NEW VERSION - Automatic Multiport Valve MIDAS March 2011

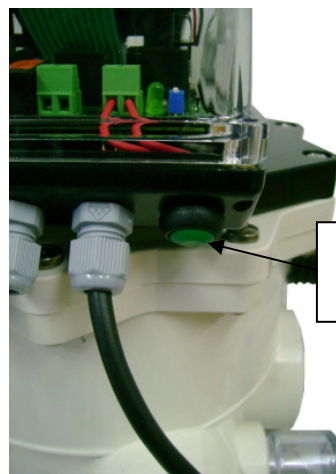
1. **A quick-action fuse 0.4 A is added to the circuit board** on the connection of the filter pump to prevent damage to the diodes of the circuit board in case of current excess because of a bad electrical connection.
2. **Changes in the text of the electronic board**: the text MOTOR-PUMP has been replaced by the numbers 4-5.
3. **Modification of the of the automatic valve manual!**: diode specifications, maintenance of the valve and an example of connecting a standard cabinet are added.
4. **A maintenance kit has been added.** It includes three fuses and grease for lubrication of the valve shaft.
5. **The backwash press button** has been included in all automatic MIDAS valves.

0.4 A Fuse

Backwash
press button
